10' X 12' ORGANIZER  
5/12 PITCH W/LEAN-TO

Re: Structural Certification  
10', 12', & 16' Organizer Sheds

ROOF FRAMING

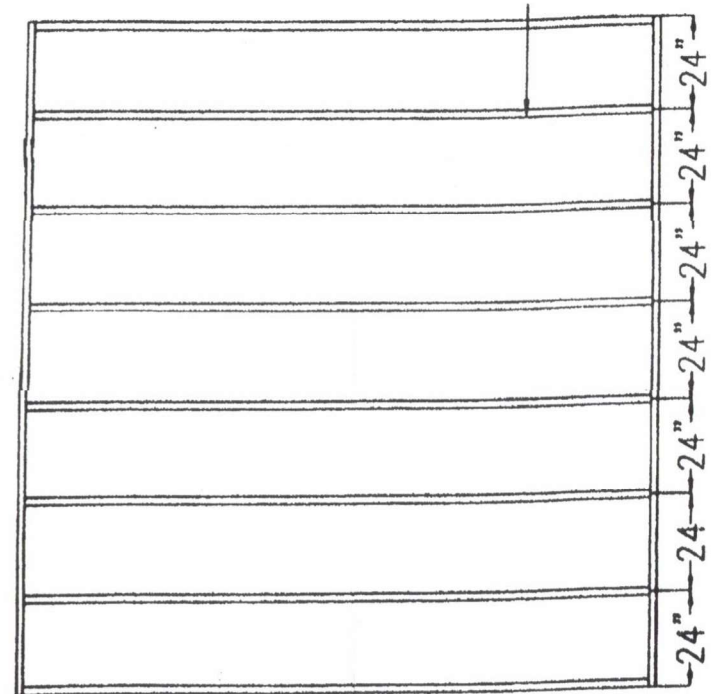
This variation consists of a 10' wide shed with a gable roof system. The roof consists of 2x4 rafters @ 2'-0" on center at either a 5:12 or 9:12 pitch, and the walls are constructed with 2x4 studs at 16" on center. Please be advised that the rafters shall be cross-tied with 2x4 collar ties located at the 1/3 point extending downward from the ridge and spaced at 4'-0" on center. The collar ties should be attached at each rafter with a minimum of (6) 10d nails
